RENESAS TECHNICAL UPDATE

Product Category	MPU/MCU		Document No.	TN-RX*-A0213A/E	Rev.	1.00
Title	Errata to the Package Code of 0.65-mm pitch 80-pin LQFP Package for RX66T Group and RX24T Group		Information Category	Technical Notification		
Applicable Product	RX66T Group, RX24T Group	Lot No.	Reference Document	RX66T Group User's Manual: Hardware Rev.1.10 (R01UH0749EJ0110) RX24T Group User's Manual: Hardware Rev.2.00 (R01UH0576EJ0200)		
		All

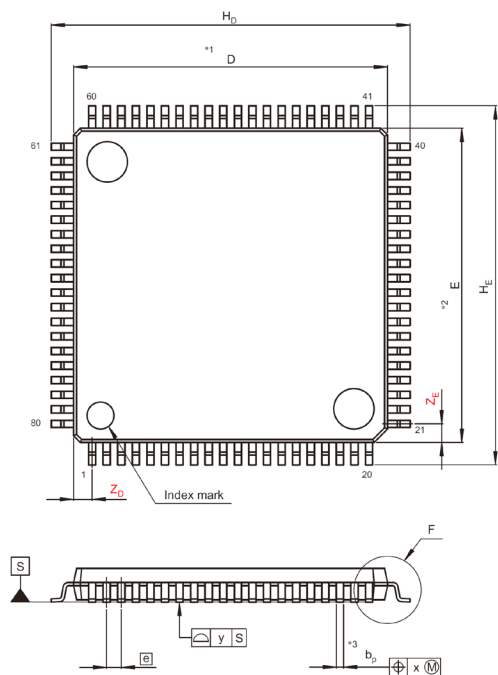
1. Correction to the Package Code (RENESAS Code)

The package code of the 0.65-mm pitch 80-pin LQFP package used with the applicable products is corrected as follows.

PLQP0080JA-~~A~~

PLQP0080JA-~~A~~**B**

After correction

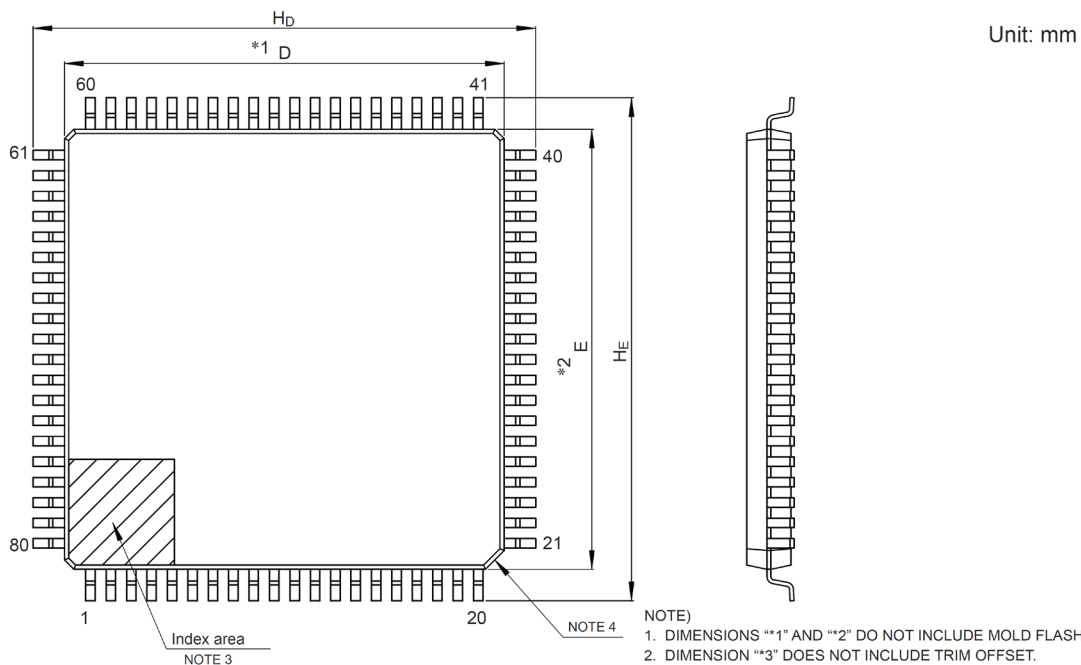
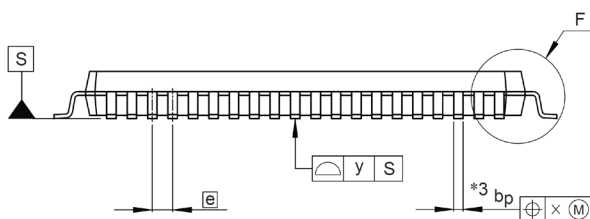
2. Changes in Package Dimensions

The package dimensions for the 0.65-mm pitch 80-pin LQFP package are also changed as shown in the following figures.

JEITA Package Code	RENESAS Code	Previous Code	MASS (Typ) [g]
P-LQFP80-14x14-0.65	PLQP0080JA-B	—	0.6

- NOTE)
1. DIMENSIONS **1" AND **2" DO NOT INCLUDE MOLD FLASH.
 2. DIMENSION **3" DOES NOT INCLUDE TRIM OFFSET.
 3. PIN 1 VISUAL INDEX FEATURE MAY VARY, BUT MUST BE LOCATED WITHIN THE HATCHED AREA.
 4. CHAMFERS AT CORNERS ARE OPTIONAL, SIZE MAY VARY.
